Consultant	Wahib Medanat Consultant Engineer	Rep No.	21-06032022
Contractor	Dijlah Establishment Constr. Contracting	Tender No.	(11/2019/USAID/SKEP/3/S) Schools for a Knowledge Economy Project (SKEP) - Phase (3) Package (1, 2)
Site Name	Hay Al Iskan Basic Mixed School- Jerash	Day/ Date	Sun. 06/03/2022
Duration of Project	450 Calendar Days	Total Project Budget	8,314,983.735 JD

SKEP III Home Office Support Site Visit Report

(Figure: 01)

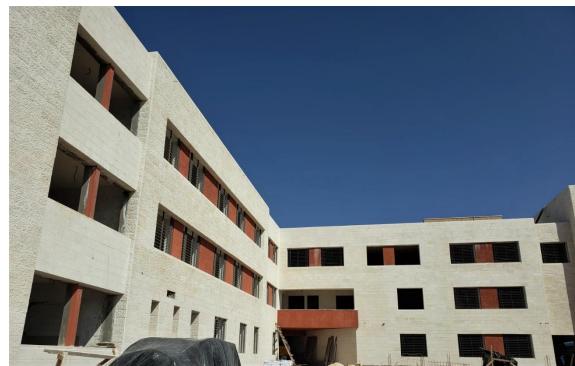
General view of the project site (Figure: 01, 02, 03 & 04)

(Figure: 22)

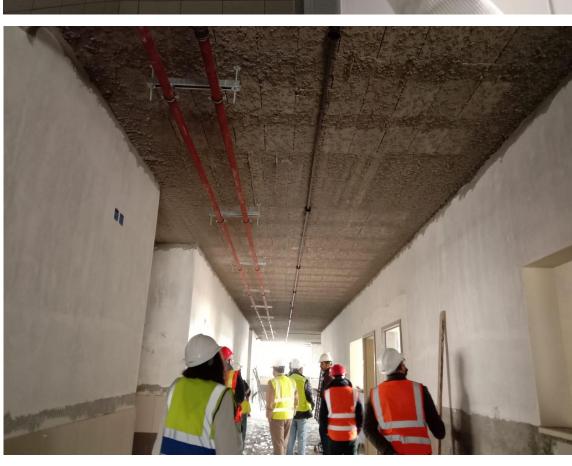
The team observed unaccepted cutting and grouting tiles adjacent to the door frames
